**ADDENDUM NO. 1**  
**TO**  
**PLANS & SPECIFICATIONS**  
**FOR THE**  
**WATER MAIN REPLACEMENT AT VARIOUS LOCATIONS**  
**IN**  
**ANTIOCH, CALIFORNIA**  
**P.W. 503-15**

**ISSUED**  
**September 23, 2015**

**WATER MAIN INSTALLATION**  
**AT VARIOUS LOCATIONS**  
**ARZATE LANE PRESSURE REGULATING**  
**STATION RELOCATION**

CD-30

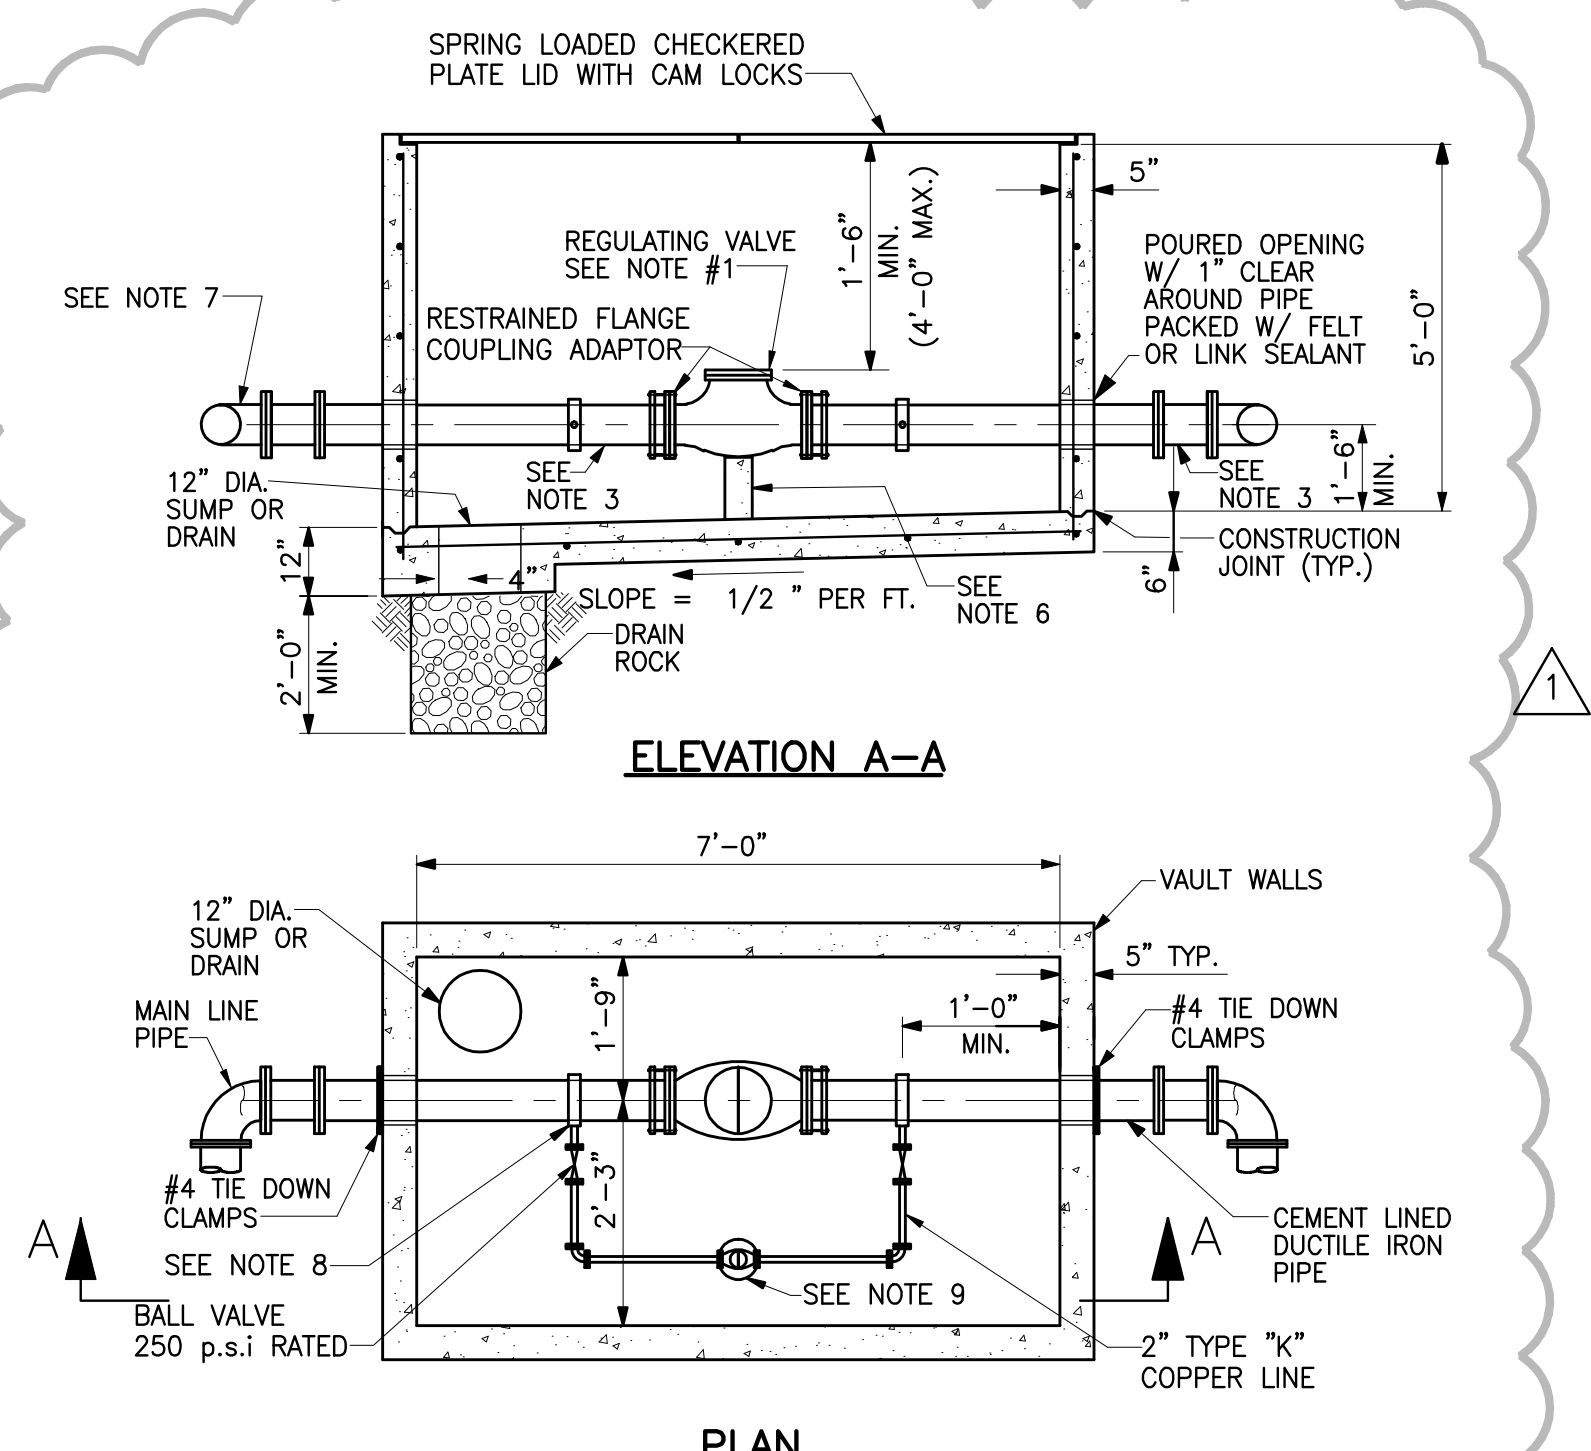
- F. Blow-Assembly. At the locations shown on the plans, the Contractor shall install two-inch (2") blow-off assemblies as per City of Antioch Standard Construction Detail No. CD-30, "Standard Water Main Blow-off Assembly", including all pipe, fittings, valves, precast concrete meter boxes, covers and thrust blocks. All pipe and fittings shall be Type "K" copper.

- 3) The attached City of Antioch Standard Construction Detail No. CD-30, "Standard Water Main Blow-off Assembly", is included in the Special Provisions.

SHEET 5R

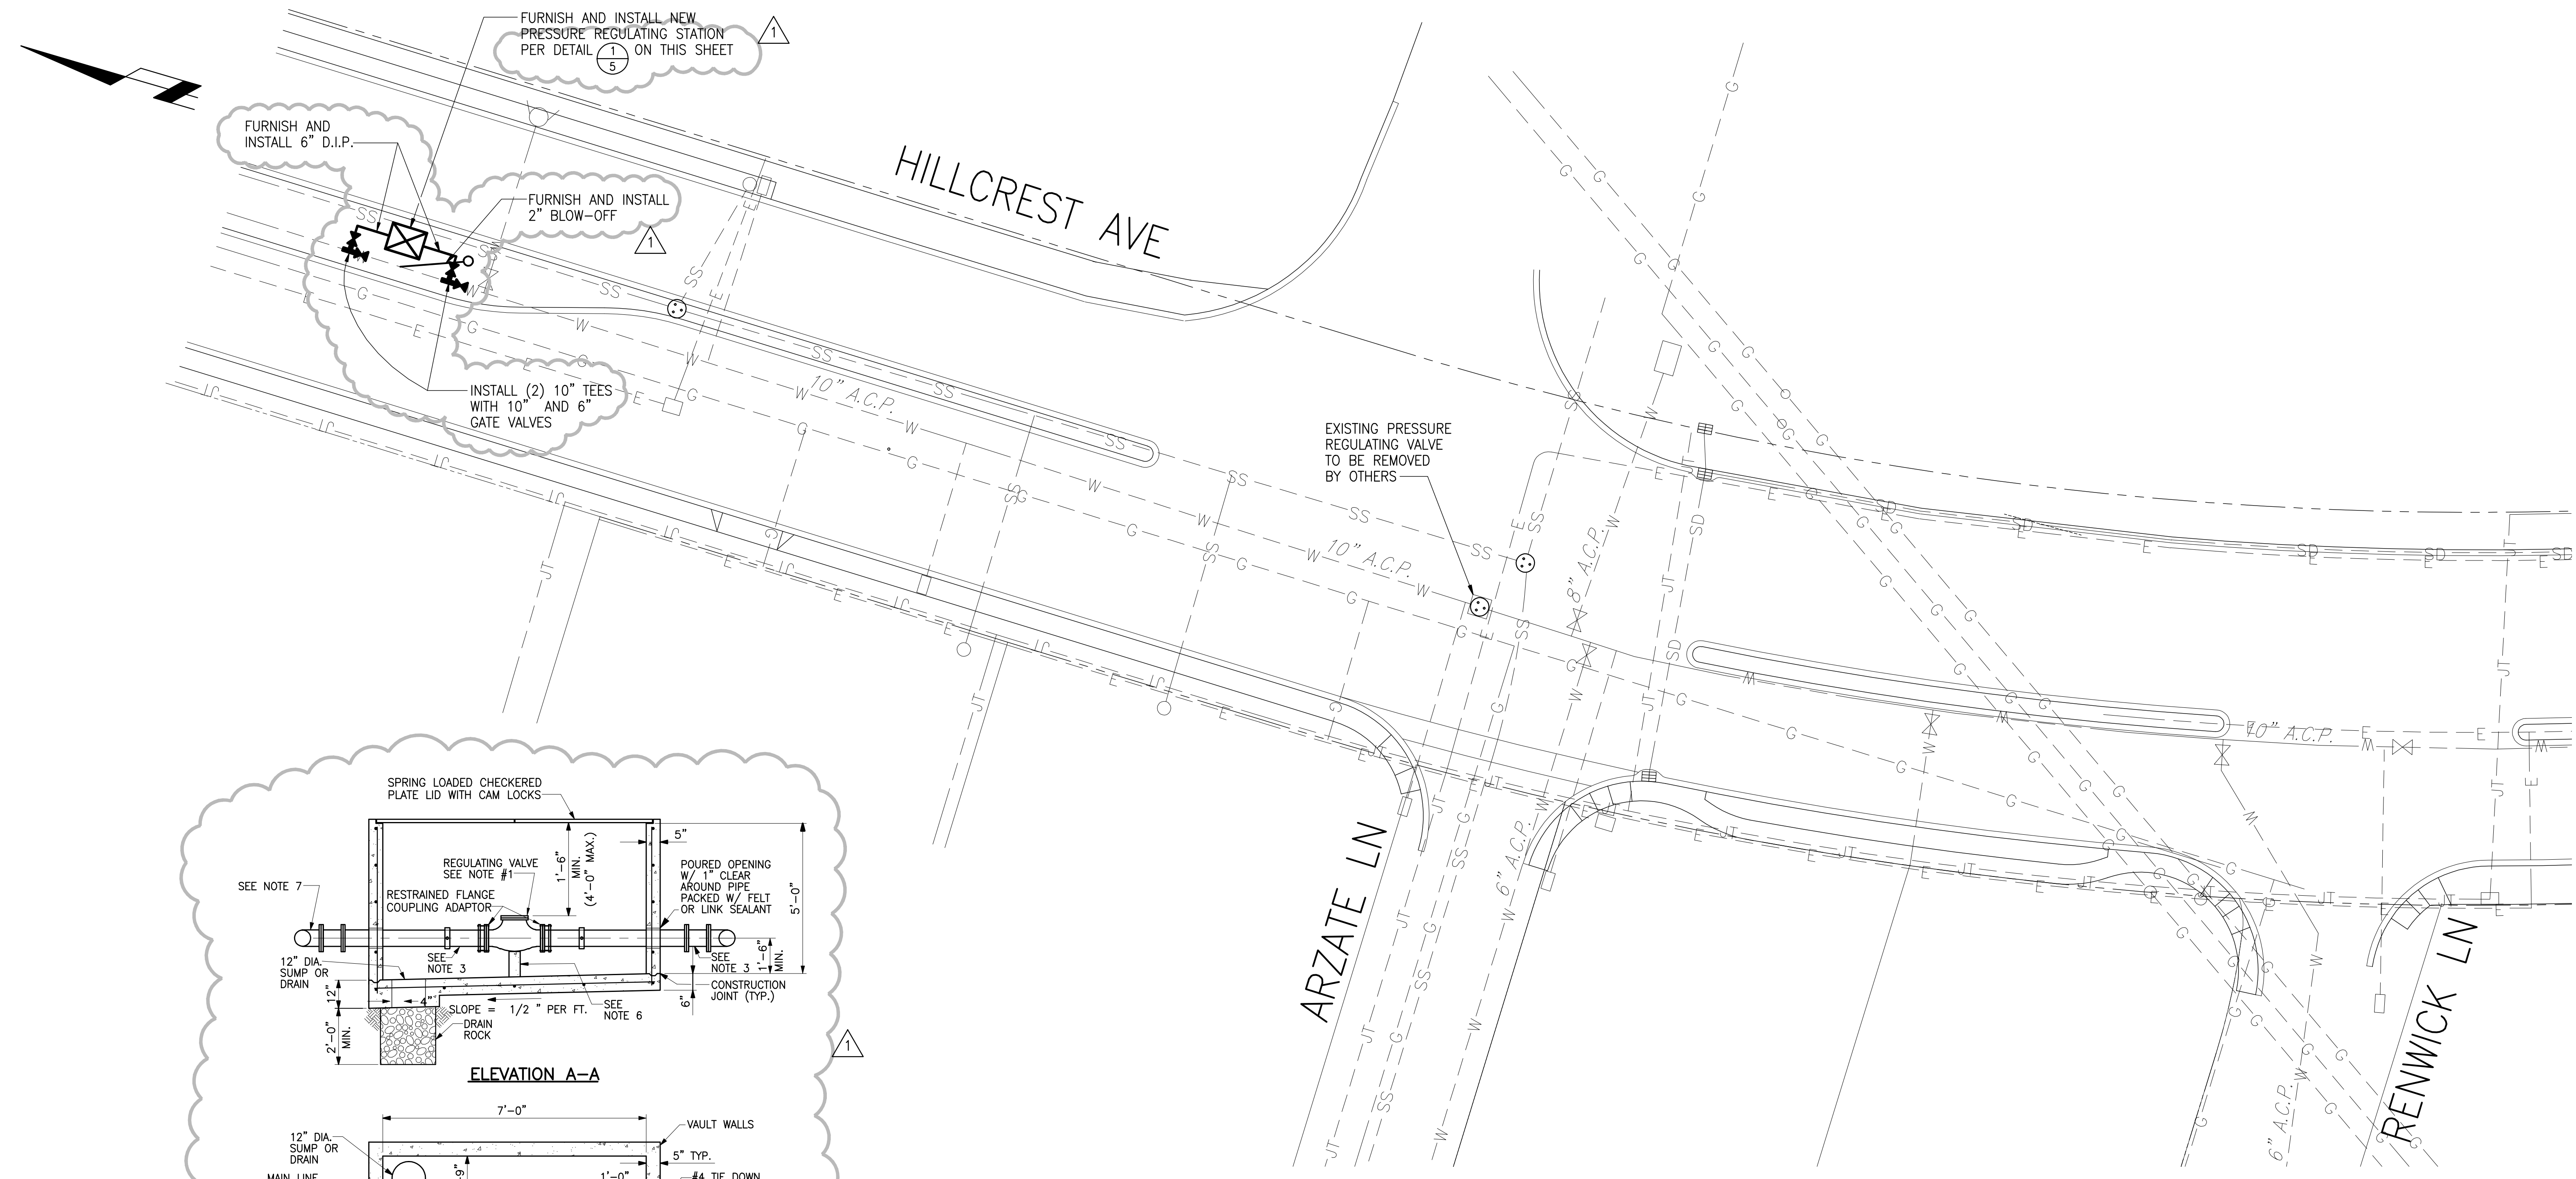
- 4) The attached revised Sheet 5R shall be use in lieu of Sheet 5 of the Project Plans.
